# Car Stereo Service Bulletin

**Model:** EXR-25; XR-4257/4357

**No.** 252

**Subject:** Tuner Pre-sets Are Lost Or "SDK" Appears  
On The Display

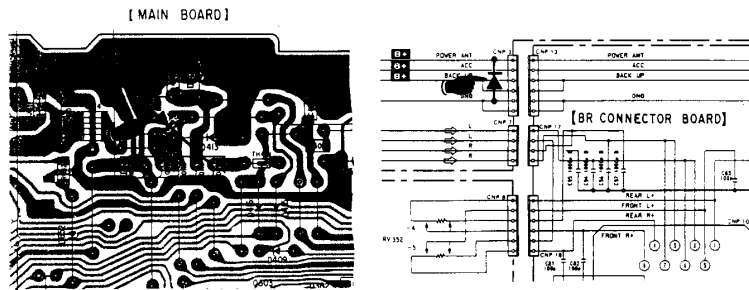
Tuner pre-sets are lost when power antenna is activated, or when unit is removed from the mounting sleeve. In some instances, "SDK" appears on the display.

- Solution:**
1. Add a 10K $\Omega$  resistor in parallel with C-411 on the main board (XR-4257 only).
  2. Add an 11ES2 diode to the power antenna circuit (REM out) on the Main MCB.
